3478 N/Floyd Terrace, Los Angeles 90068

MUNICIPAL CODE VIOLATION ENFORCEMENT HEARING

ORDER TO COMPLY

RE: Order to Comply- 3478 Floyd Terrace (AKA 3209 Craig Dr.), And 3474 Floyd Terrace
Los Angeles, CA 90068

Fig 1 Large

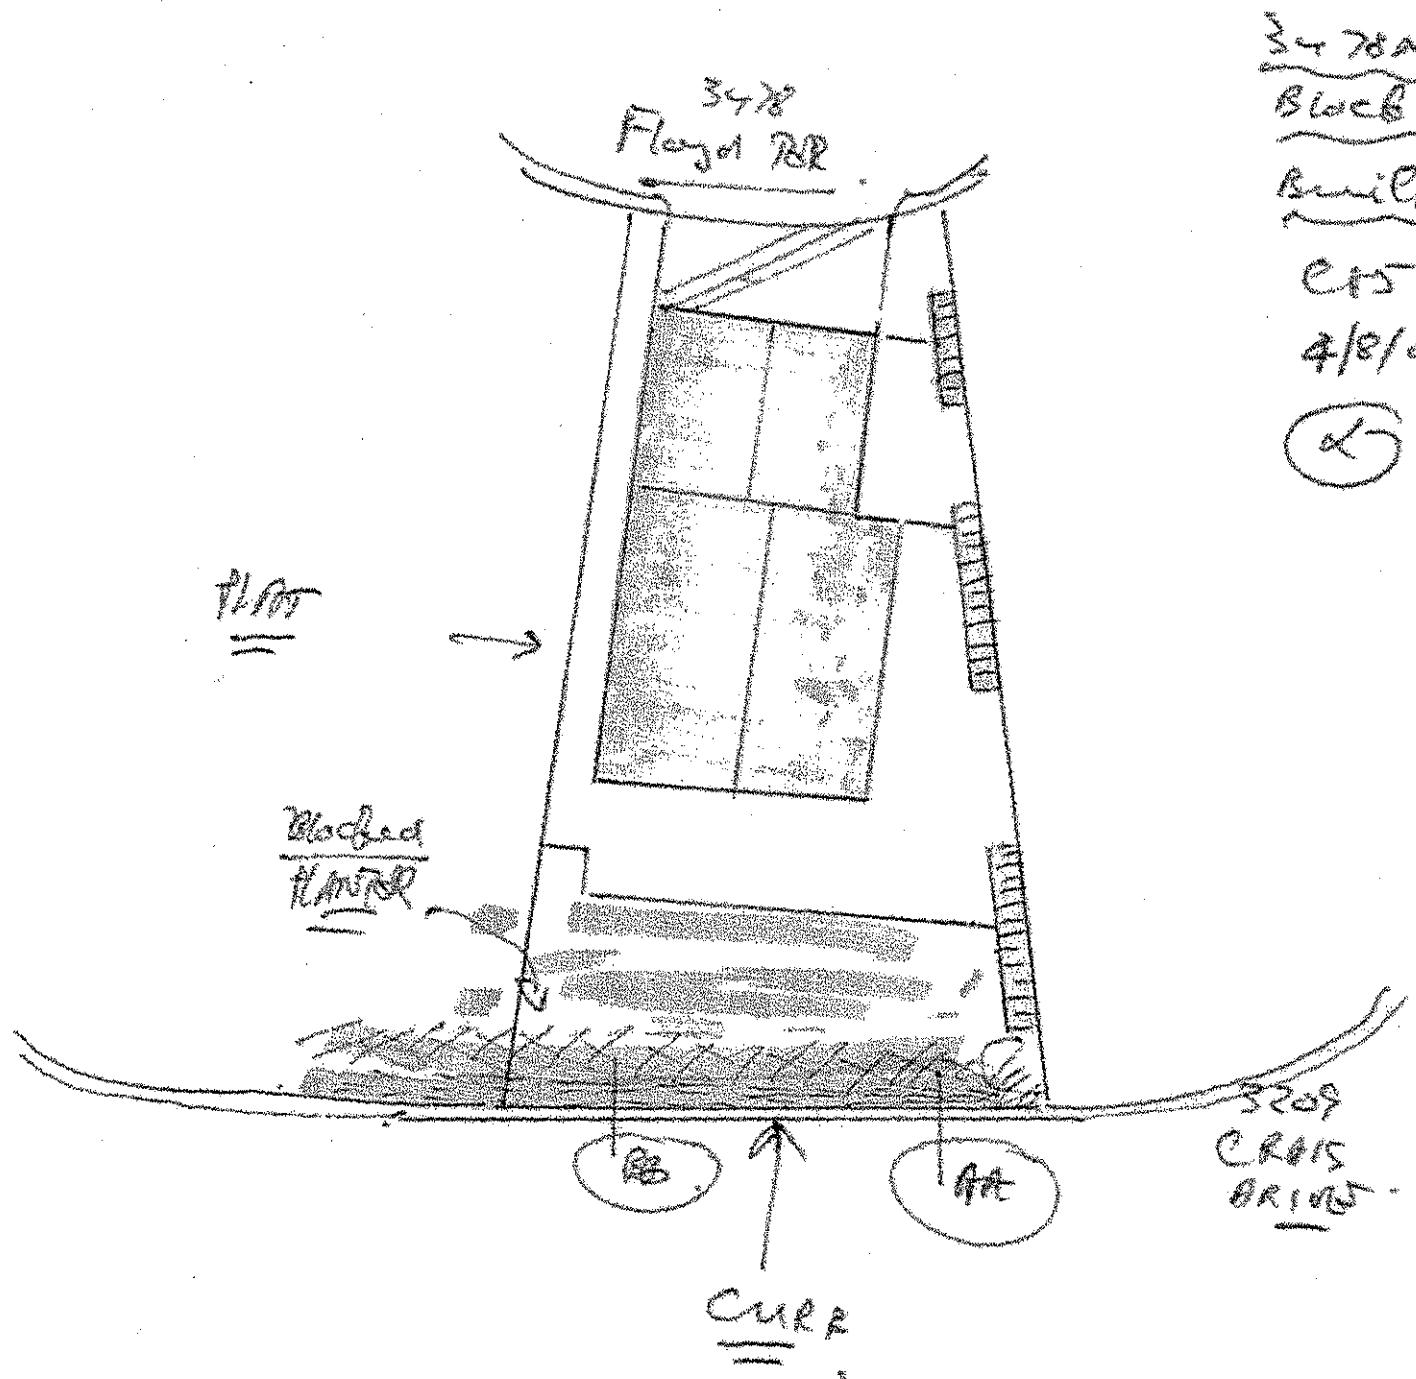
1. Plot plan showing dwelling and retaining walls in question;

The diagram will show the dwelling, as well as the side steps that are located on the north side of the house. This diagram is provided for a general view of the location of the wall and other structures on the property. Please see fig 1 large, also Fig 1 on composite page below.

Fig 2 Large

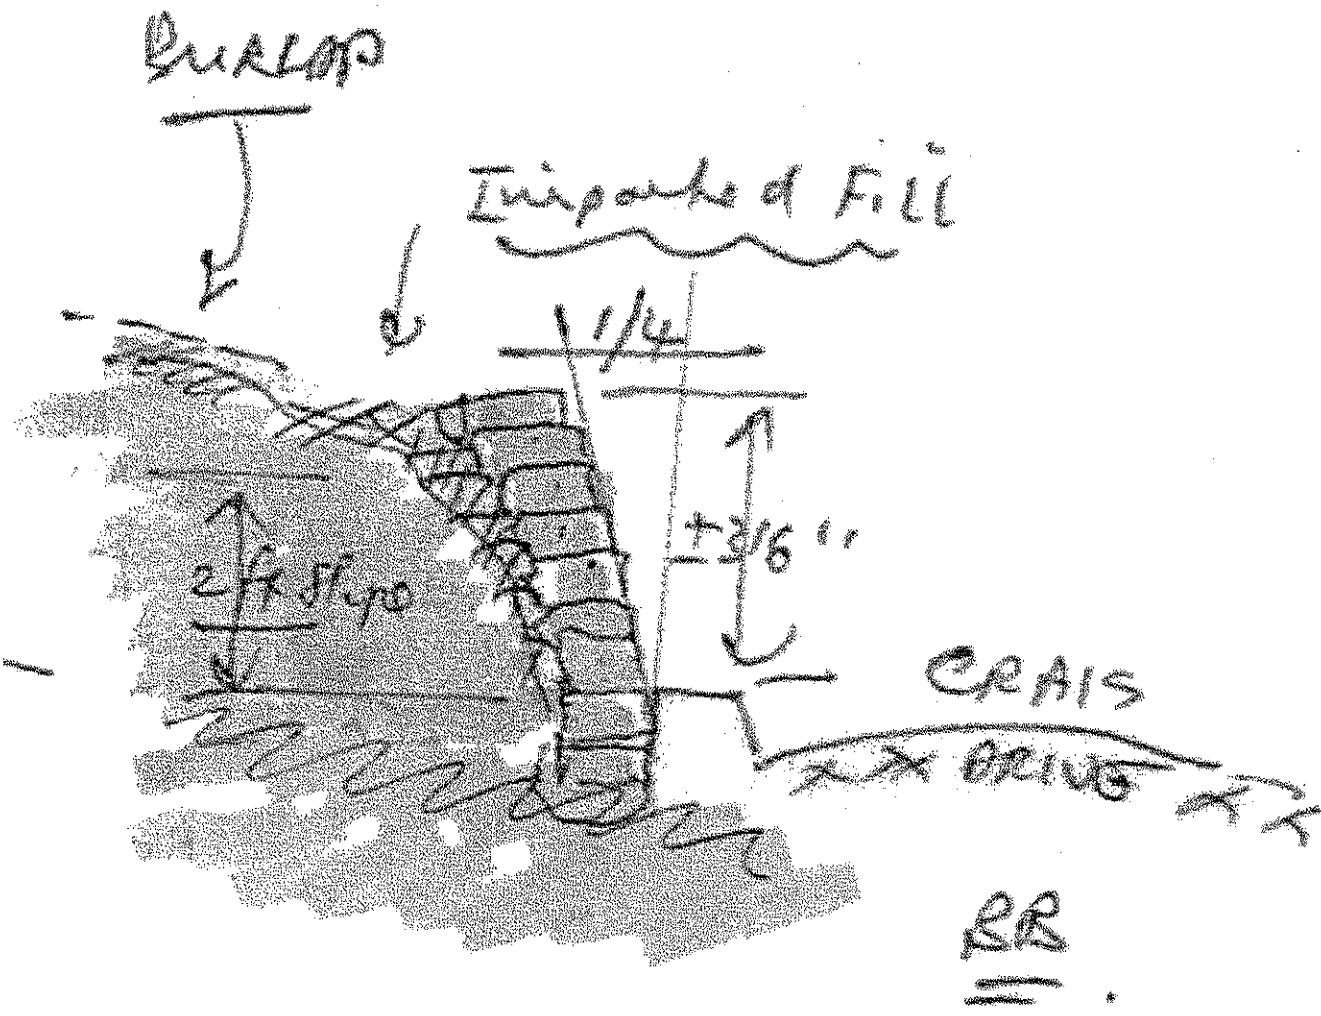
2. Cross-sections through walls. The sections should show, if possible, the material the walls are founded on in (important);

Please see Fig 2 and 3 as well as fig 2 and 3 on composite page below showing all three diagrams of block wall.
